SUNDRY NOTICES AND REPORTS ON WELLS
Do not use this form for proposals to drill or to re-enter an abandoned well. Use Form 3160-3 (APD) for such proposals.

PRIMERO OPERATING, INC.
 George Fed Com #1
 API# 30-005-62694

George Federal Com 1
30-005-62694
Primero Operating, Inc.
June 20, 2019
Conditions of Approval

Permanent Abandonment of Production Zone Conditions of Approval

PROPOSED PLUGS

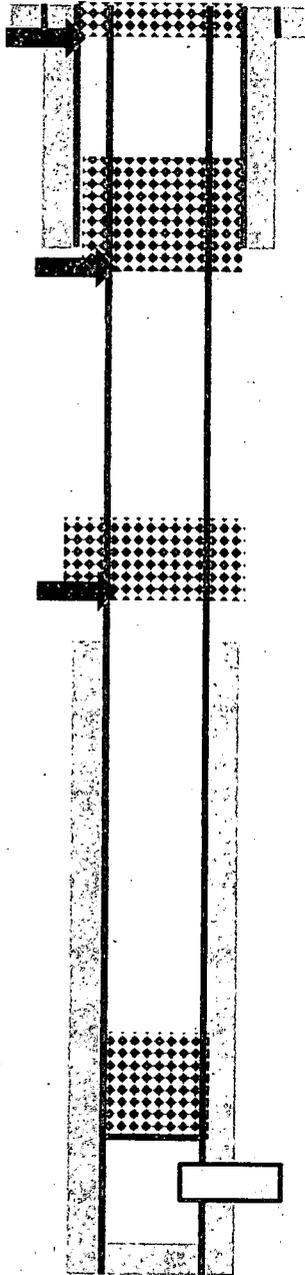
1. Operator shall place CIBP at 3,745' (50'-100' above top most perf) and place 25 sx of Class C cement on top as proposed. WOC and TAG. Tag a minimum of 3400' to ensure the Abo Formation is isolated.
2. Operator shall perf and squeeze at 1,647' as proposed. Operator shall place a balanced Class C cement plug from 1,647'-1,527' to seal the Glorieta Formation.
3. Operator shall perf and squeeze as proposed at 805'. Operator shall place a balanced Class C cement plug from 805'-459' as proposed to seal the 8-5/8" casing shoe. WOC and TAG.
4. Operator shall perf and squeeze as proposed at 100'. Operator shall place a balanced Class C cement plug from 100' to surface.
5. See Attached for general plugging stipulations.
